TITLE: MODIFICATION KIT FOR UNBALANCED OUTPUT & AIR INTAKE

GPT 10K( ) SERIES

KIT361

The purpose of the modification kit is to facilitate rear intake cooling of air to the auxiliary frame and provide unbalanced output termination point on the top of transmitter in lieu of the conventional GPT-10KW side output termination.

FIGURE 1

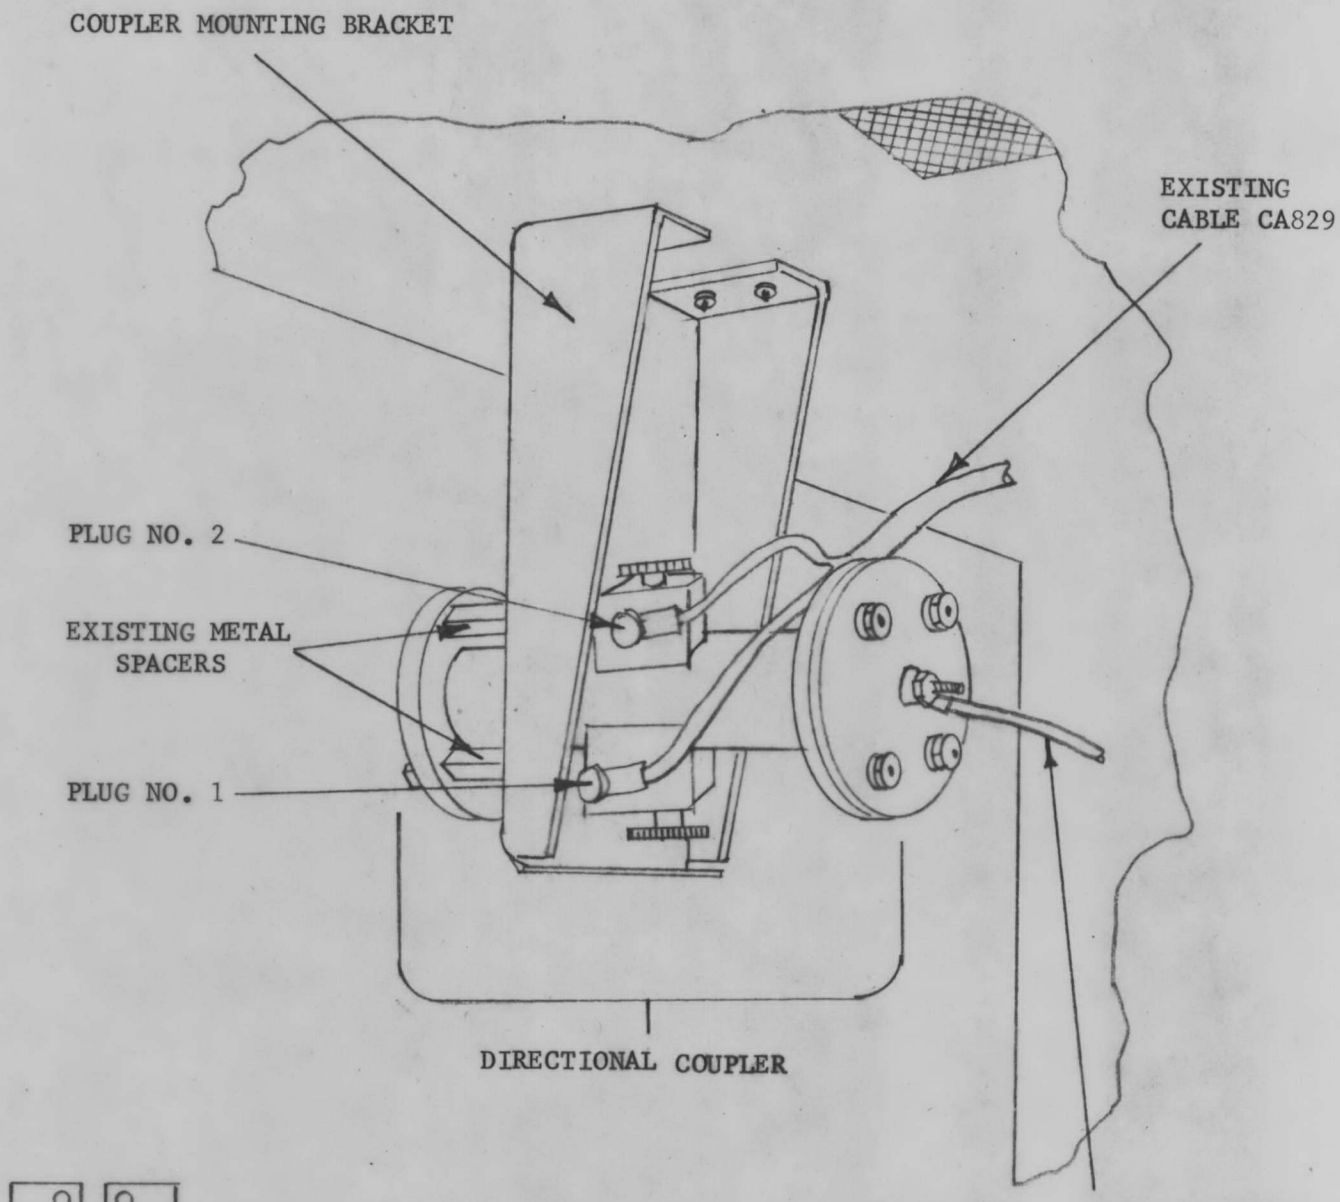
1. Disconnect wire from E904 to the threaded stud in the center on the end of directional coupler DC-900. (discard wire and save hardware).

2. Disconnect cable CA-829 (part of frame wire harness) plug numbered 1 (or REF) from the bottom rear side of directional coupler DC-900. Disconnect cable plug numbered 2 (or FWD) from top rear side of directional coupler DC-900. (Both plugs will be reconnected once directional coupler has been relocated.) Remove plug in diodes from the coupler & do not discard).

3. Remove mounting hardware on directional coupler mounting plates (MS2702) from the outside of transmitter. Carefully remove mounting plates and then directional coupler from coupler mounting bracket. Save mounting plates with spacers attached

FIGURE 2

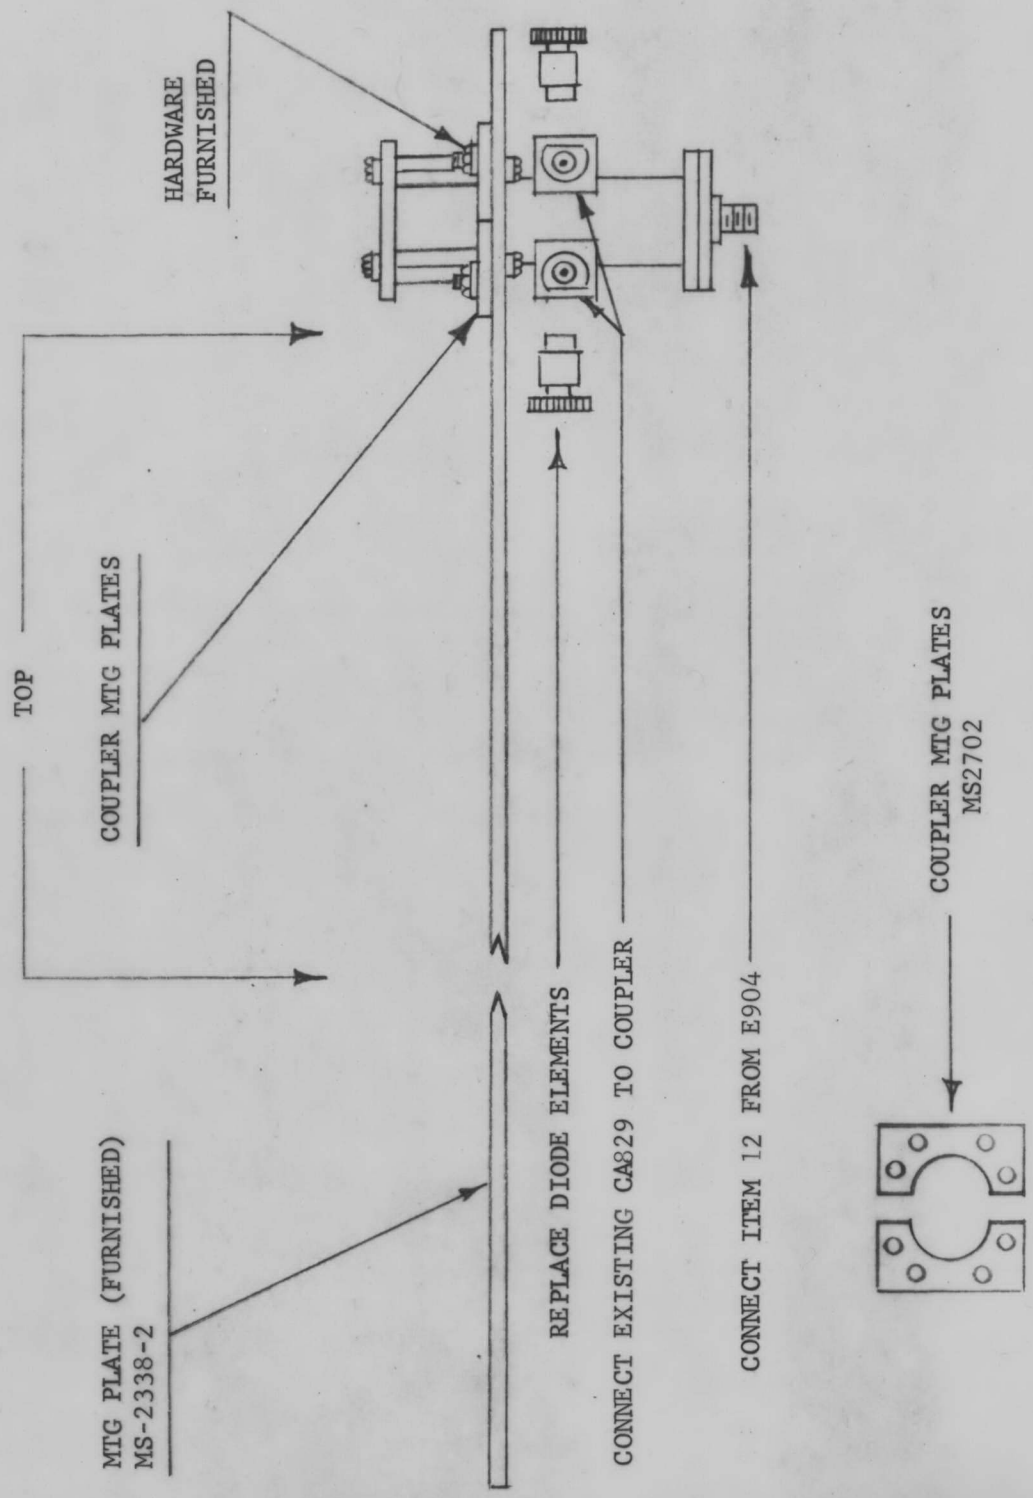
Once coupler has been removed from transmitter, the coupler must first be installed on modified balanced output bowl cover plate (Item 1, P/N MS-2338-2). This installation must be performed in the following manner: (Refer to Figure 2)

5. Place Item 1 (modified balanced bowl cover plate, MS-2338-2) over directional coupler. (Cover plate must be positioned with counter-sunk holes facing work bench and large hole on right side.)

6. Place directional coupler mounting plates (2 plates that were removed when coupler was removed from transmitter in step 3) under swivel end of directional coupler with four metal spacers facing up, lift cover plate (Item 1) until flush with mounting brackets. Align the eight (8) counter-sunk holes with the eight holes on mounting bracket.

7. Install Item 6 (1032 Flat head screws) in the eight counter-sunk holes on the underside of the cover plate. Secure item 6 with flat washer, item 8; lockwasher, item 9; hex nut, item 7.

8. Take coupler assembly (coupler and cover plate mounted together) and mount on TOP OF TRANSMITTER with the bottom portion of directional coupler extending through the right balanced bowl hole. (Right balanced bowl hole as viewed from the front of transmitter)

9. Secure coupler assembly to top of transmitter frame with items 2, 3, 4 and 5 (8/32 screw, binder head; flat washer, split lockwasher and hex nut).

10. Connect Item 12 (CA412-2-6.00 insulated lead) from E904 to threaded stud end of directional coupler, secure connection with hardware that was previously used prior to modification.

11. Replace diode elements in their respective sockets.

12. Connect Cable CA-829 (part of frame wire harness) plug numbers 1 and 2 to the jacks located on directional coupler. Dress the remainder of the cable and secure with cable clamp provided (Item 13). Cable marked #2 connects to forward power diode, cable #1 connects to reflected power diode.

FIGURE 3

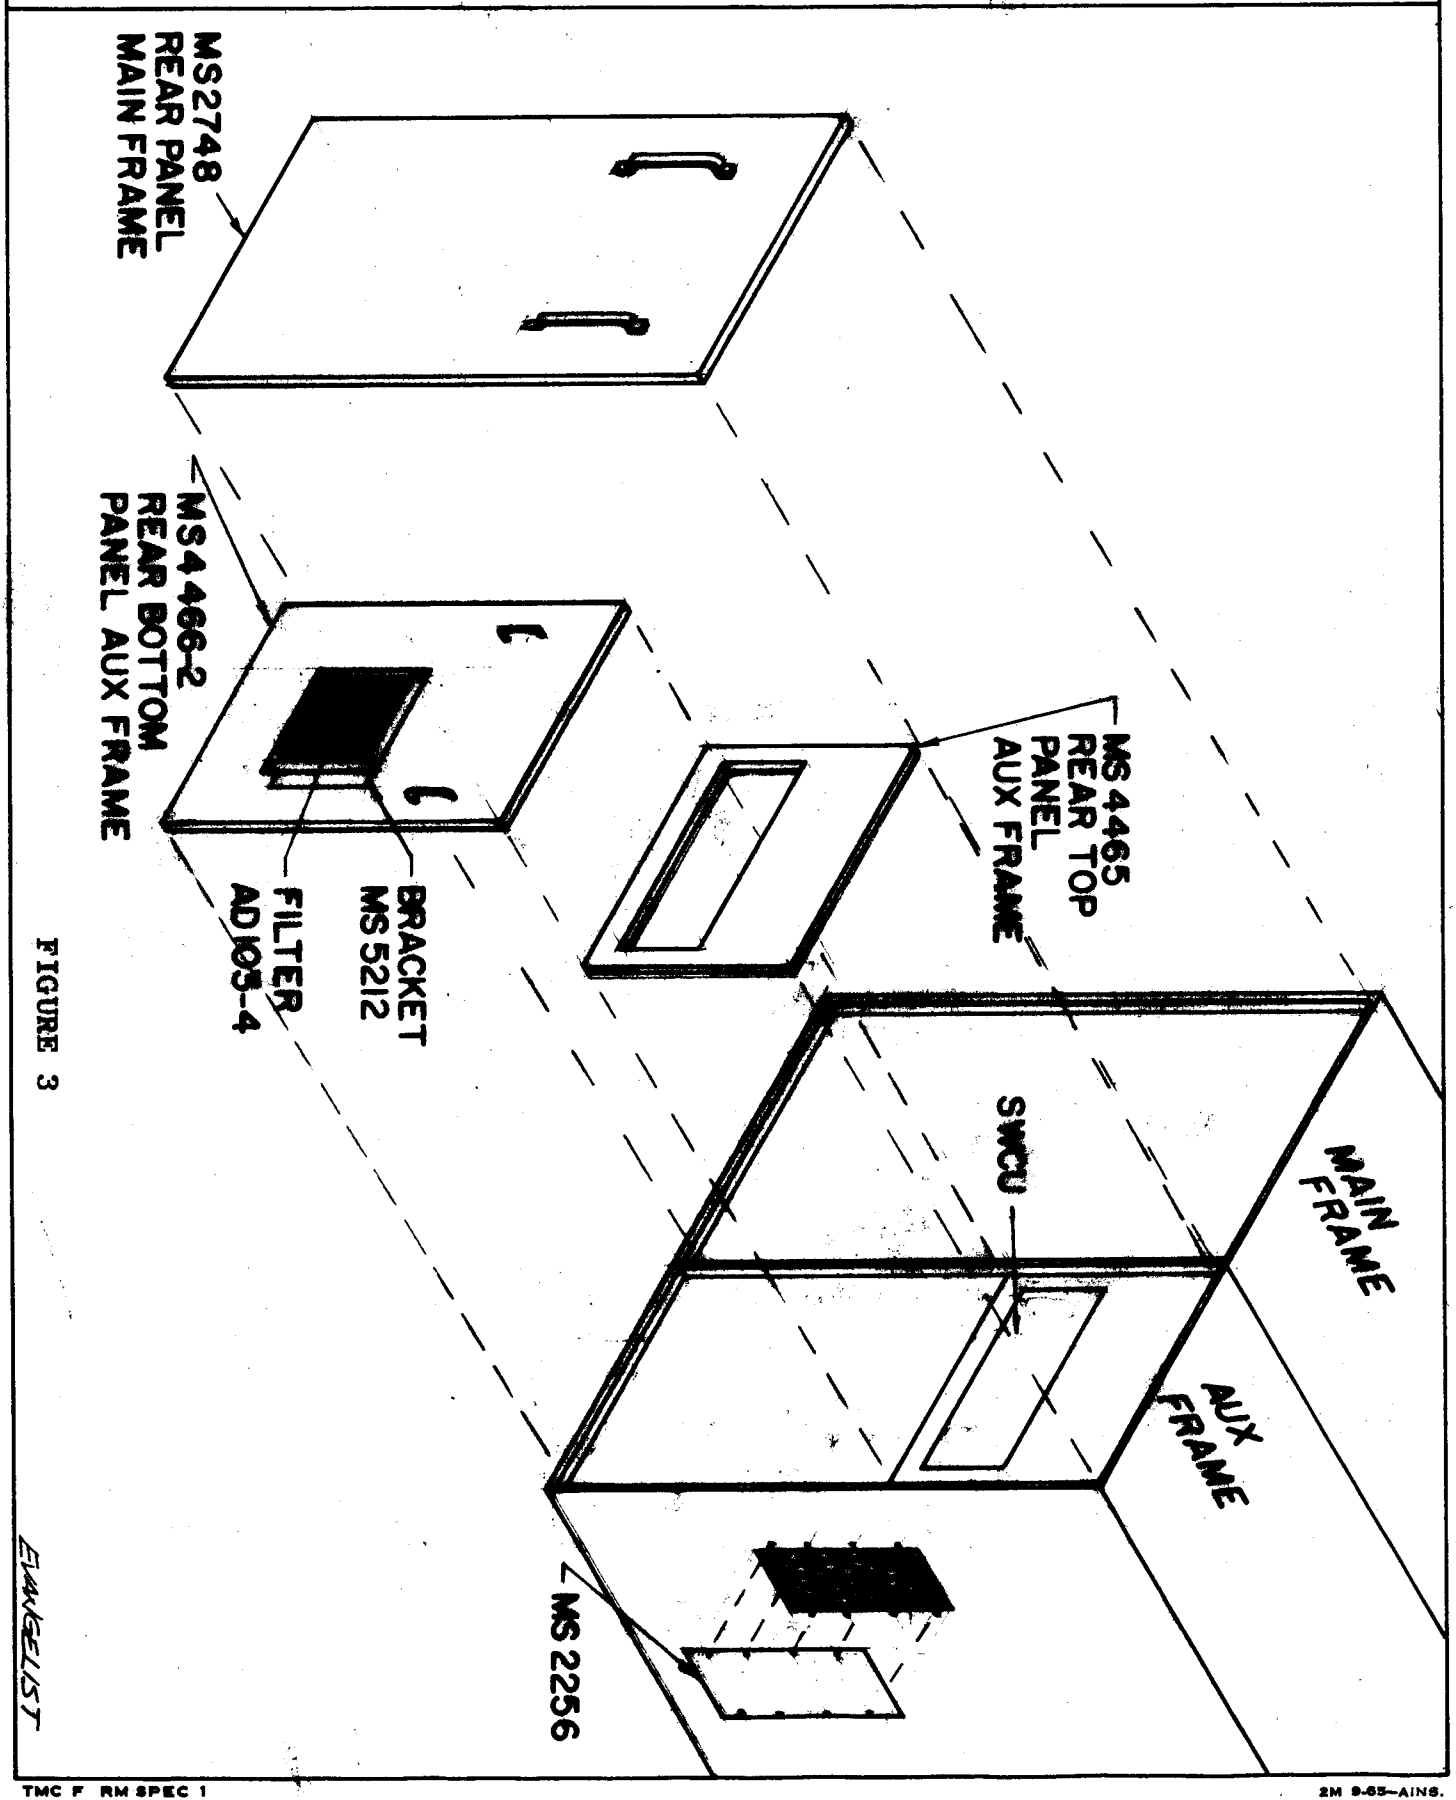
1. Install item 18 (cover plate) in place of filter grill (removed in step A-2)

2. Install item 15 (Top Panel) center opening over (SWCU) panel.

3. Install item 16 (Bottom Panel)

4. Install item 14 (Main Frame Panel)

5. Affix item 20 (nameplate) below transmitter overall nameplate to indicate completion of modicication
